UNITED STATES PATENT AND TRADEMARK OFFICE

APPLICATION NO.	FILING DATE	FIRST NAMED INVENTOR	ATTORNEY DOCKET NO.	CONFIRMATION NO.
10/009,696	11/06/2001	John Eric Arnold	DN1999111USA	1392

# Office Action Summary

## **DETAILED ACTION**

# ATTACHMENT # 1

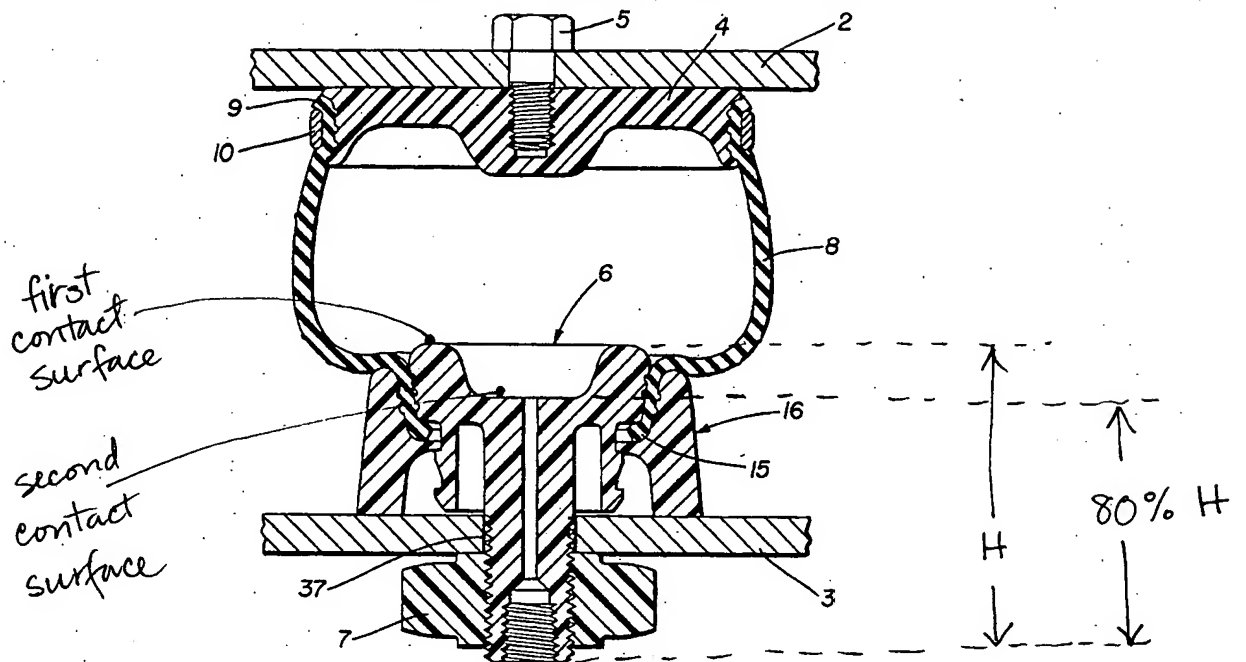
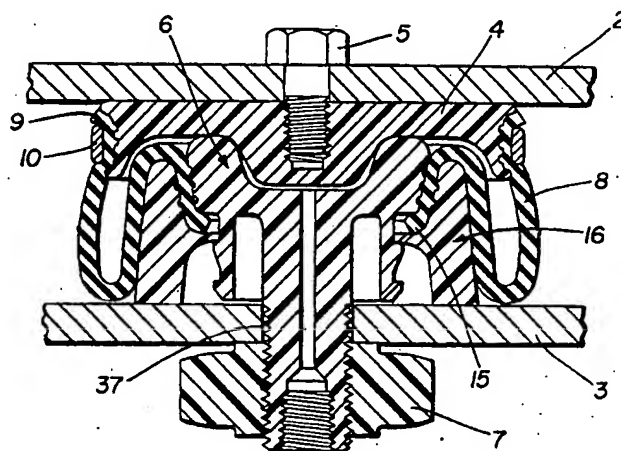
Re: claim 1, Leonard shows an airspring, as in the present invention, comprising: a flexible sleeve 8; first retainer 4; second retainer 6; wherein second retainer 6 having an integral bumper-contact surface (see attachment #1) within the sleeve 8 for axial movement into the sleeve, for contact with the first retainer 4; and for absorbing and transmitting forces generated from such contact.

Re: claims 5 and 6, please see attachment #1 where the Examiner marks the first contact surface, the second contact surface and the proportions of the heights as claimed.
